JERRY'S POND IMPROVEMENTS DESIGN REVIEW

City of Cambridge
April 20, 2023

Completed by: Kleinfelder, Hatch
DRAFT

Figure 2 - Friends of Jerry's Pond (FoJP) Improvements Plan.

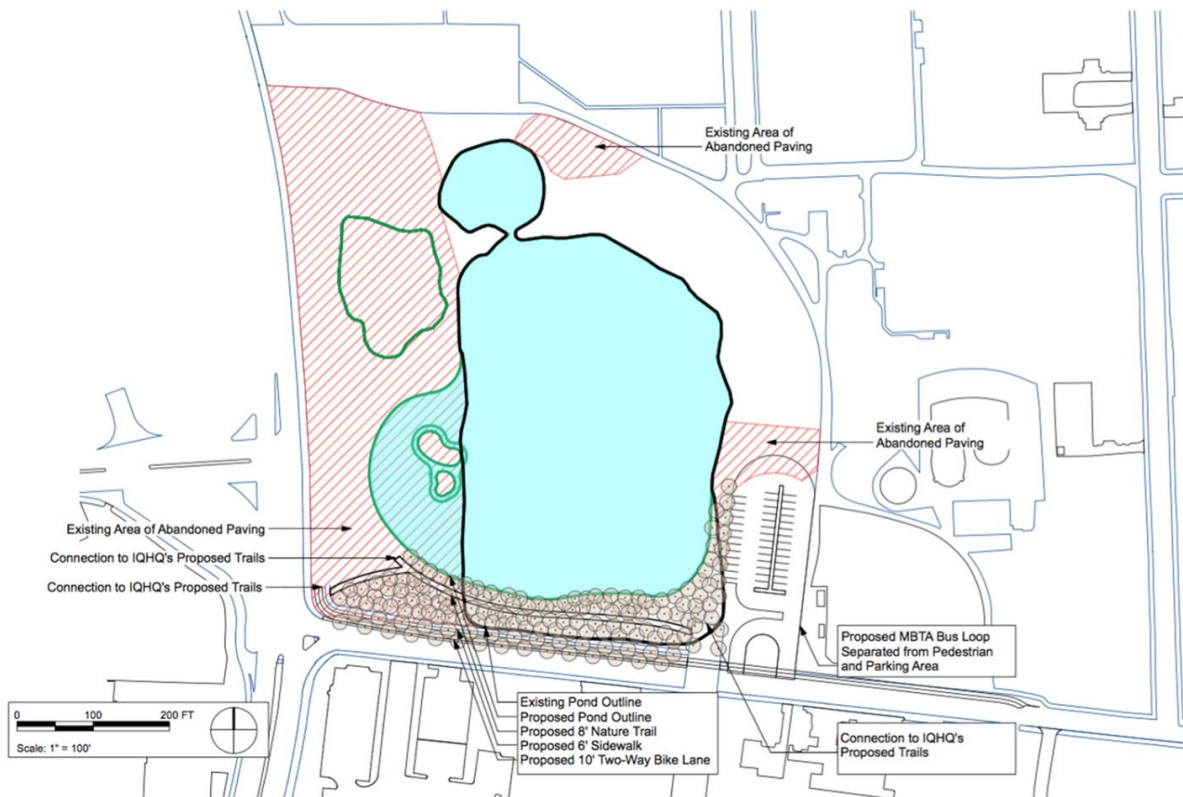
The FoJP proposal is a major earthwork (excavation and grading) project to reshape the pond and the adjacent upland areas to the south (Rindge Avenue) and west sides of Jerry's Pond (**Figures 2 and 3**). The FoJP Plan proposes the re-use of onsite soils from the excavated pond area for the construction of the expanded land along Rindge Avenue. The filling of Jerry's Pond along Rindge Avenue (approximately 0.74 acres above the water line) allows for the on-grade construction of a sidewalk, nature trail, two-way bicycle path, and a vegetated slope into the pond. The filling of Jerry's Pond below the water line is estimated at 0.8 acres.

Work elements illustrated in the FoJP plan would require the removal of 72 large trees (>6" caliper), significant soil disruption, and an inability to effectively restore the shoreline and created aquatic habitat due to an unstable and highly variable urban hydrology.

The FoJP Plan proposes habitat improvements in the form of a wetland shelf (littoral zone) and riparian slope plantings. Hydrologically, the long-term establishment of a healthy and functioning aquatic shoreline will be difficult to ensure based on an unstable and highly fluctuating urban pond that is underlain by clay and has a small subwatershed and no controlled outlet. Greater fluctuations in water levels caused by predicted (future) increases in the frequency and intensity of rainfall events will also have a negative effect on long-term aquatic plant establishment.

Up to 175 new tree plantings are proposed along Rindge Avenue to mitigate for trees removed as part of the western pond expansion, promoting cooler temperatures in summer months and improved wildlife habitat. However, a total of 72 significant trees will be removed resulting in a caliper loss of 909 inches. As such, the City would require 501 (2" caliper) trees to be planted as required by the City's Tree Ordinance. The mitigation payment if the trees were not planted is estimated to be over \$727,000 (\$850/caliper inch). In the FoJP plan, there is no opportunity to save the existing significant trees (7 total) along Rindge Avenue.

The FoJP plan also proposes the creation of two island rookeries by preserving existing trees within the pond's (western) expanded footprint. Unfortunately, the (southernmost) trees used for heron nesting will be removed and the construction of a new heron rookery does not guarantee that the birds will use the islands as a new nesting habitat.

The FoJP Plan allows for a greater separation of paths and a vegetated slope with a narrow, emergent wetland at the expanded water's edge. This would require significant excavation (approximately 14,800 cubic yards) and fill being brought in to expand the land northward into Jerry's Pond (approximately 15,500 cubic yards). The amount of earthwork necessary to create the expanded shoreline along Rindge Avenue may be cost prohibitive if contaminated soils are encountered, and the disturbance would not be consistent with the Activity and Use Limitation (AUL) designation.

The construction of three new paths (sidewalk, bicycle, and nature trail) along Rindge Avenue increases impervious surfaces and runoff into Jerry's Pond. Currently, only a narrow concrete sidewalk exists near the pond. The FoJP Plan also proposes seating and picnic areas along Rindge Avenue, along with the sidewalk improvements and the construction of a new multi-use path along Alewife Brook Parkway that are also included as part of the IQHQ Plan.

Additional benefits with the FoJP Plan are the potential for improved and expanded ecological habitat and functions associated with the expanded slope, and greater direct public exposure to some of the created native plant communities. Associated risks with the FoJP Plan are seen in the earthwork/soil handling, and the success of habitat restoration and site improvements, along with permitting and timing delays that may arise. A new fence will most likely need to be constructed along the water's edge as a public safety measure as the new pond edge will drop off steeply. The FoJP plan is currently not supported by the property owner (IQHQ).
